CERTIFICATE OF APPROPRIATENESS – Minor Alteration

ISSUED: April 16, 2020 (Addendum to March 16 Roof CoA)

Mountain View Community Church of Fort Collins
201 Whedbee St.
Fort Collins, CO 80524

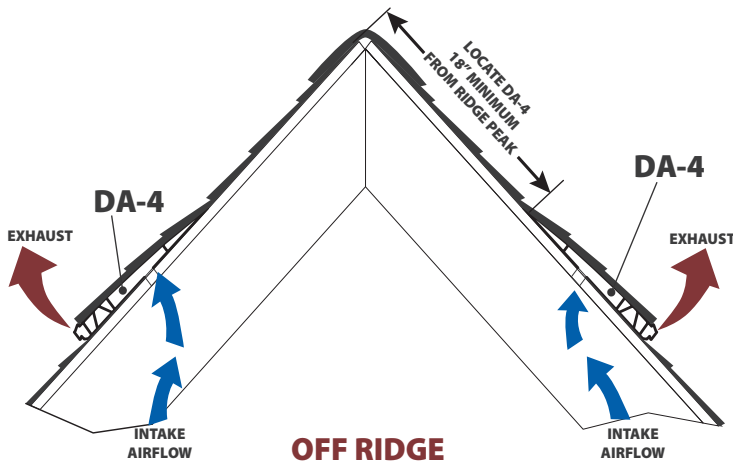
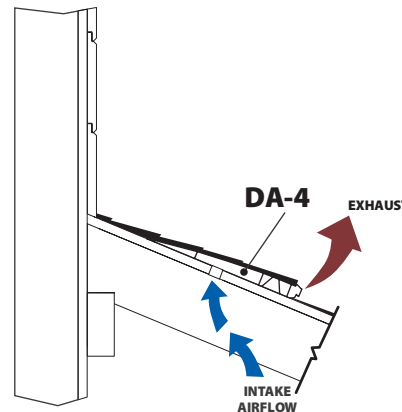
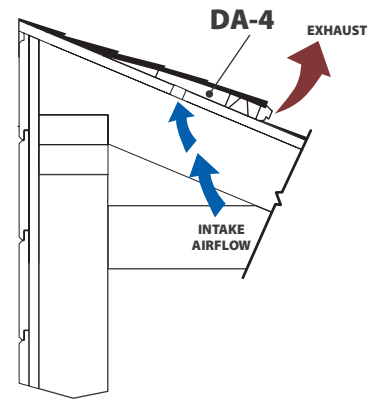
Sorry to send multiple emails on this. Could you also clarify what type of eave vent you're planning to install? (a link to the product info online is fine). There's a couple different product types out there so I want to make sure. What I've often seen referred to as "edge vents" are excellent for a property like this where the eave line is a distinctive feature of the building. Something that's more of a soffit might be problematic due to the style and exterior materials of the building. Just send me a note once you're able. Thanks!

Please see the attached eave vent we are planning to install.
